Re: Supplemental Information for Corpora Farms Permit Applications –
Responses to Questions/Comments from District Consultants

Thornhill Group, Inc. (TGI) received from you on June 2, 2023 the e-mailed transmittal of questions and comments from Ground Water Consultants (GWC) and Advanced Groundwater Solutions (AGS) regarding the Corpora Farms Aquifer Evaluation Report that TGI prepared and is dated March 17, 2023. This letter provides our responses to those questions and comments.

Revised Figure 7:
1-Year Analytical Drawdown

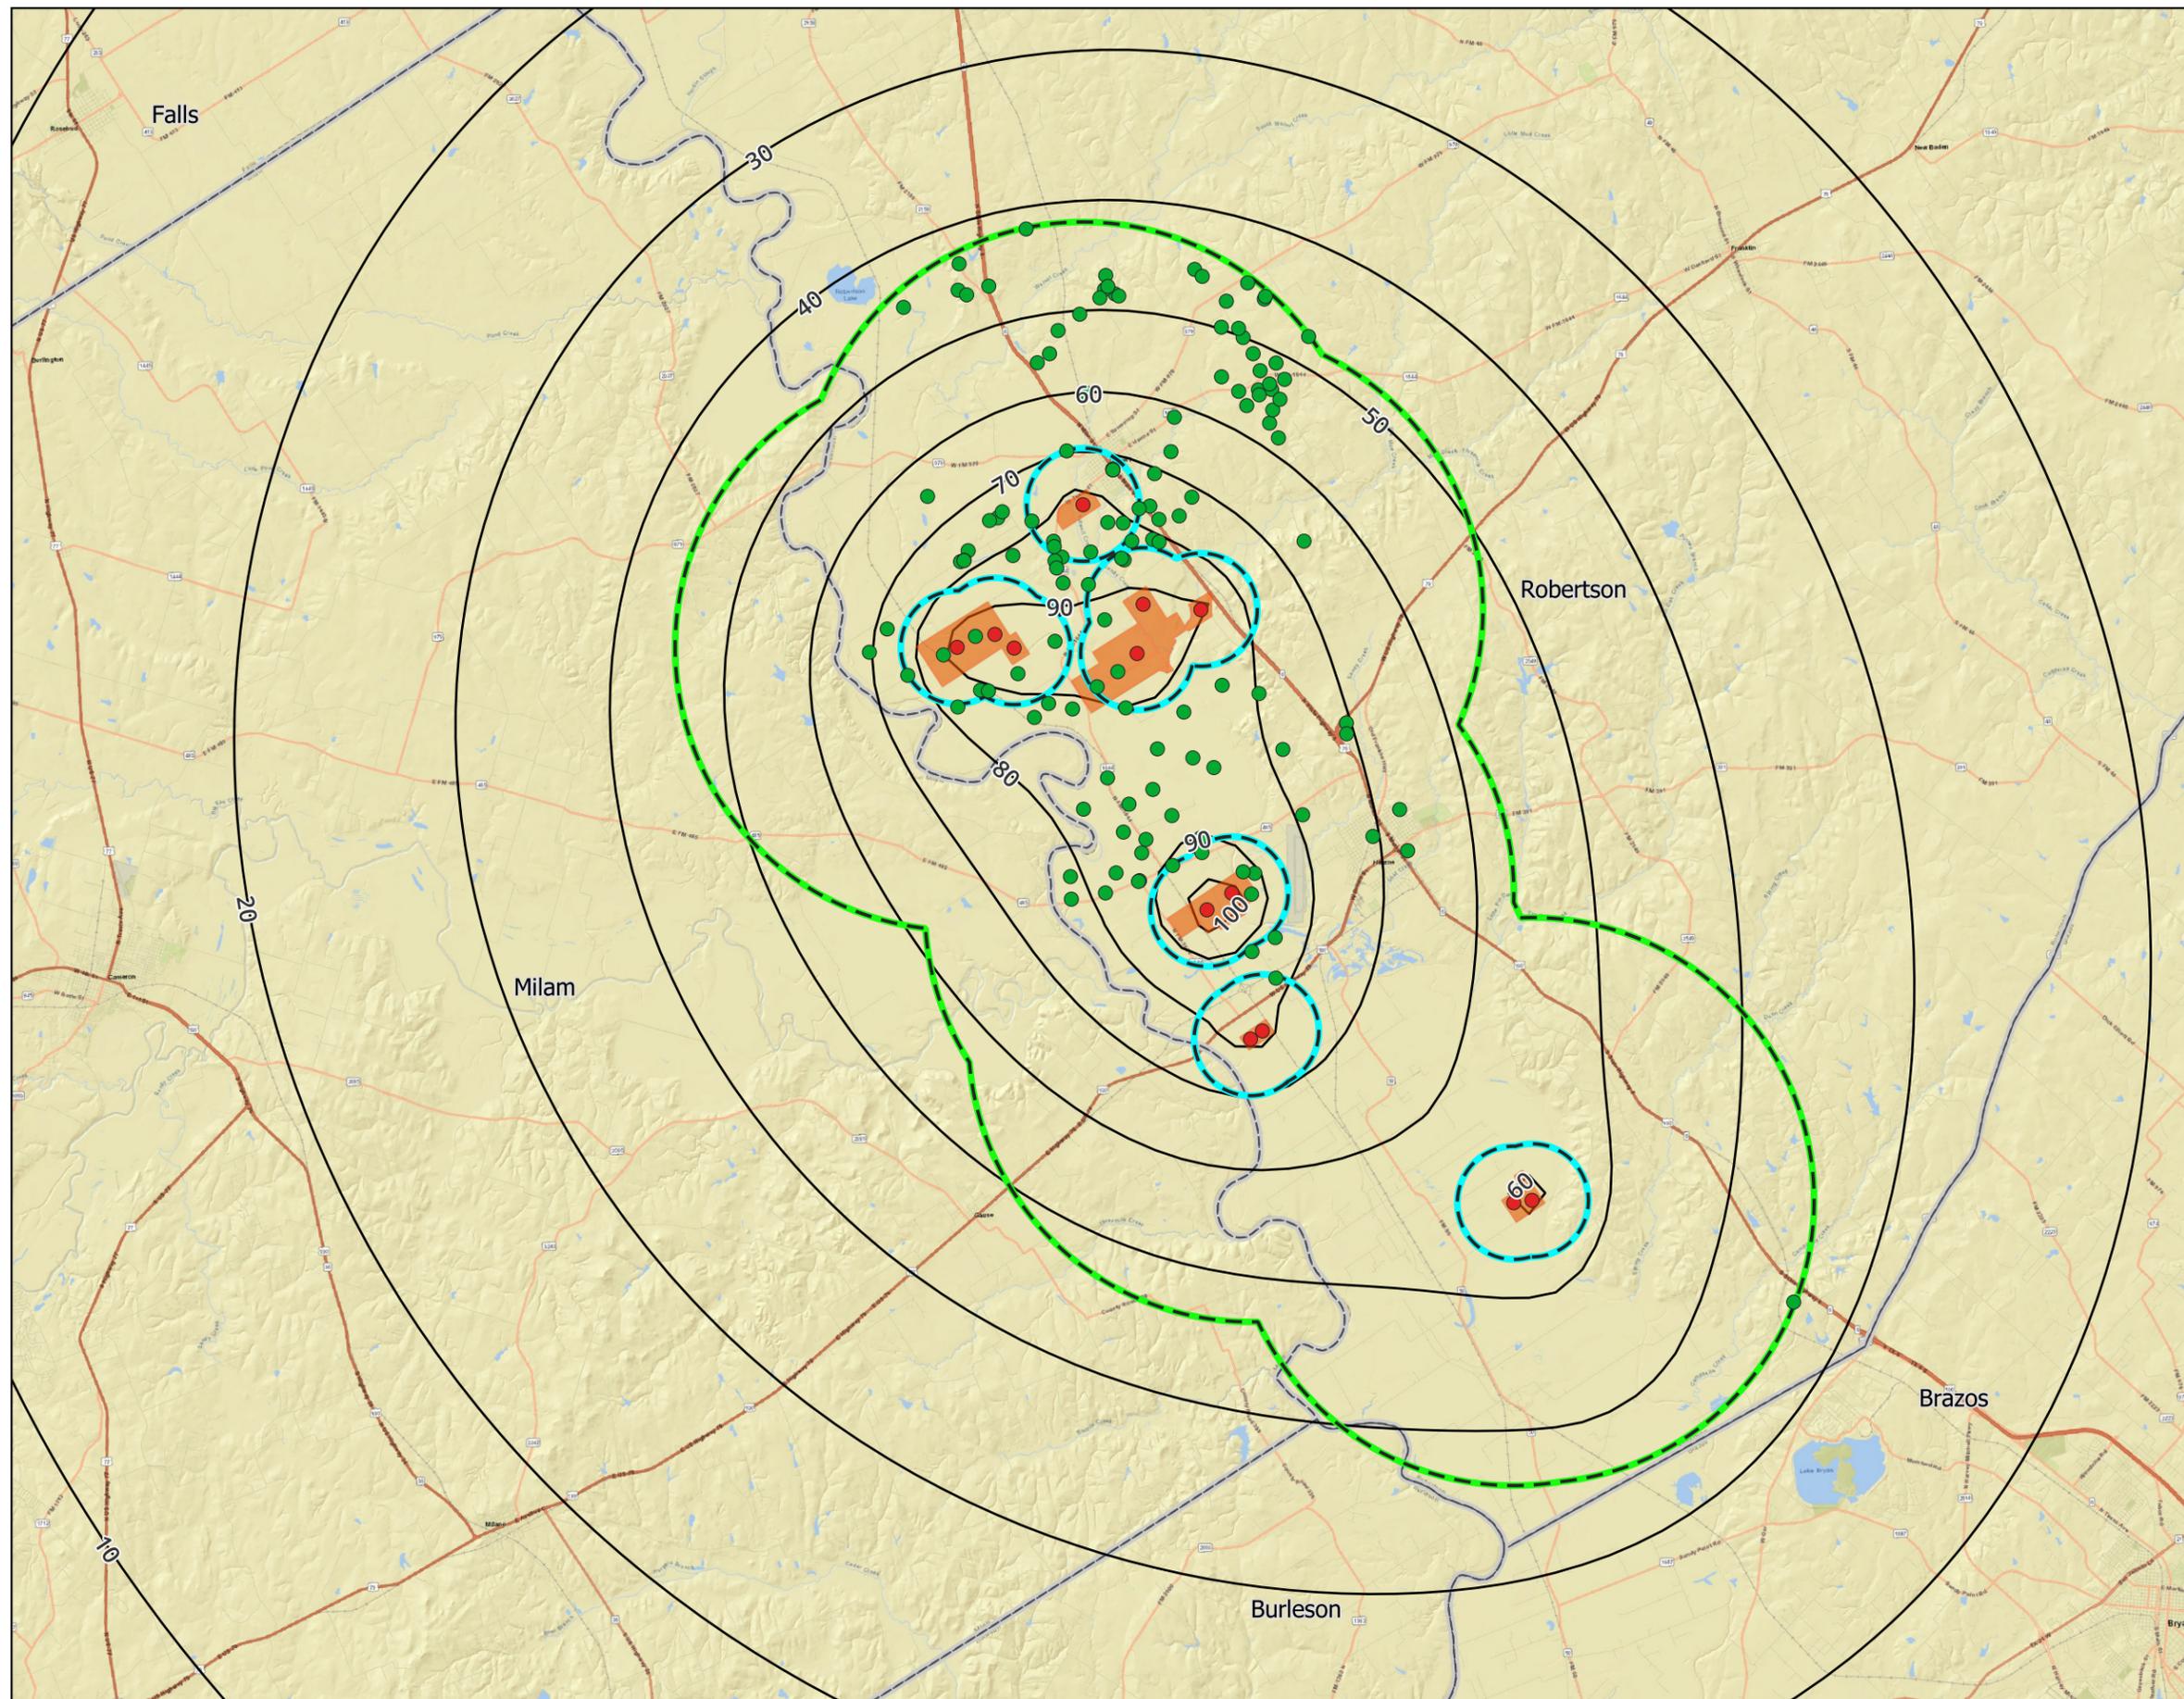
6. *Please check the 1-year and 10-year GAM and analytical modeling results shown in the table on Page 10 of 11 of the TGI Aquifer Evaluation Report. Some drawdown values shown in the table on Page 10 of the TGI report are not in agreement with the contours shown on Figures 5, 6, 7, and 8 in the TGI Aquifer Evaluation Report.*

- b. *We were able to generally recreate the 1-year and 10-year analytical model results for most of the wells shown on Table 1 of the Aquifer Evaluation Report; however, there are large differences between the simulated drawdown results at the Corpora wells shown in the table on Page 10 of 11 of the TGI Aquifer Evaluation Report and the results obtained during the AGS analytical modeling verification simulations. AGS used the Corpora well production rates and aquifer properties outlined in the Aquifer Evaluation Report to estimate drawdown values at 1-foot from the well(s). Please elaborate on the TGI methodology, if different from the above, used to estimate the*

analytical model results at the Corpora wells shown in the table on Page 10 of 11 of the TGI Aquifer Evaluation Report.

TGI noted discrepancies in the analytical values. We could not replicate Mr. Bluvstein’s Theis calculations and noted that several of the well location inputs were in error; therefore, TGI re-constructed the analytical calculations in accordance with the methodology used in our previous reports submitted to BVGCD. We have re-created the drawdown maps and corrected the tabulation. Please replace Figure 7 and Figure 8 in the original Aquifer Evaluation Report with Figure 7 (Revised) and Figure 8 (Revised), respectively. Also, please replace the table on Page 10 of 11 of the original Aquifer Evaluation Report with the tabulation below.
